SAMPLING AND ANALYSIS PLAN AREA OF CONCERN 590 (AOC 590) AND SOLID WASTE
MANAGEMENT UNIT 102 (SWMU 102) ZONE E CNC CHARLESTON SC
8/6/2002
SOUTH CAROLINA DEPARTMENT OF HEALTH AND ENVIRONMENTAL CONTROL

RE: Sampling and Analysis Plan (Revision 0), AOC 590 and SWMU 102, Zone E
Charleston Naval Complex (CNC)
SC0 170 022 560

ENGINEERING COMMENTS
Prepared by Jerry Stamps
Charleston Naval Complex (CNC)
August 6, 2002

Figure 1
AOC 590 BEQS
Soil Samples
Charleston Naval Complex

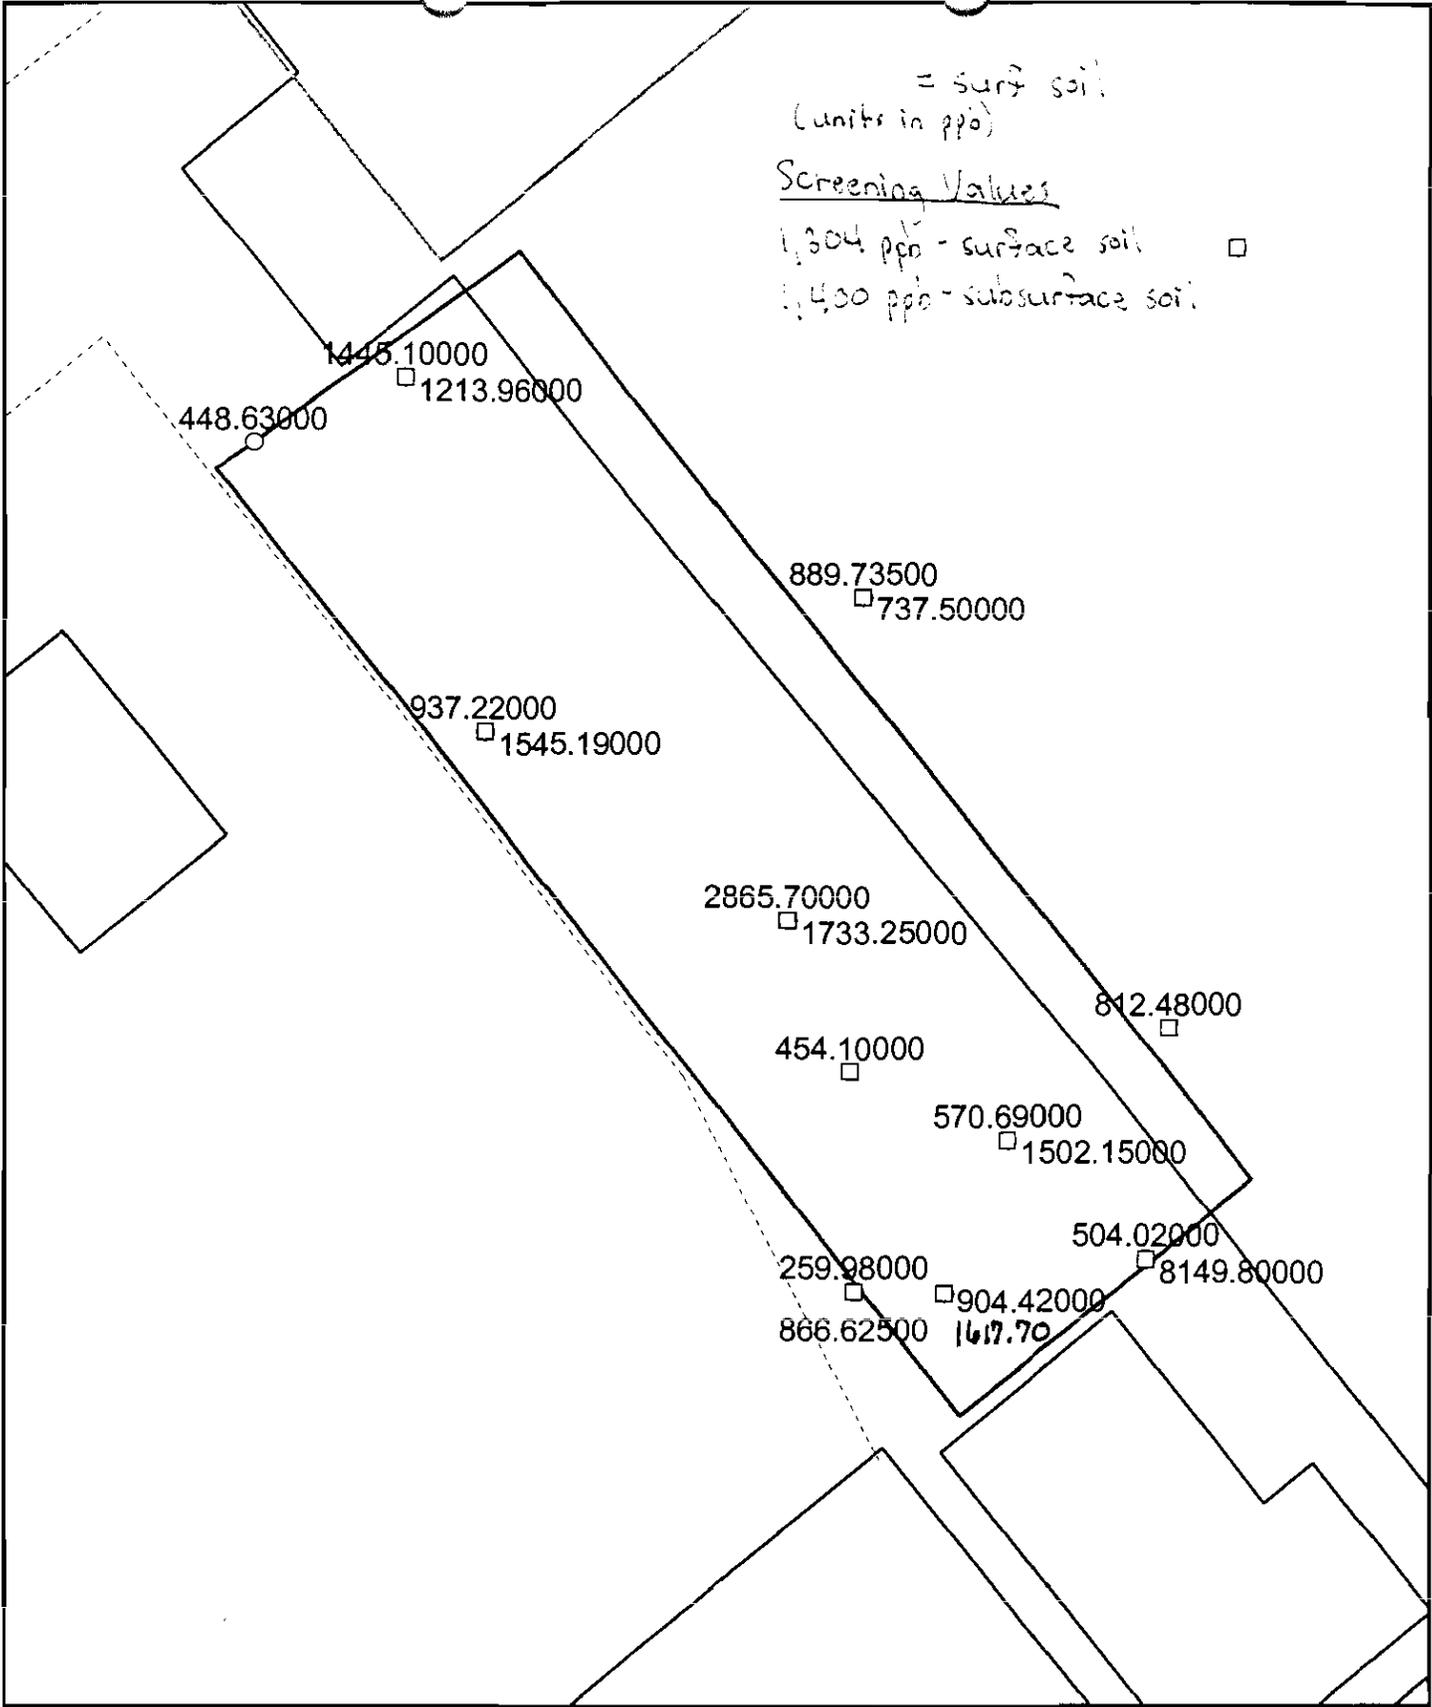
4. **AOC 590, BEQ Investigation**

According to the GIS, additional investigation for BEQs is warranted for AOC 590. Several exceedances of the BEQ screening values as documented in the *Project Team Notebook and Instructions* were identified. Please see the attached figure identifying the distribution of the BEQ contamination at AOC 590.
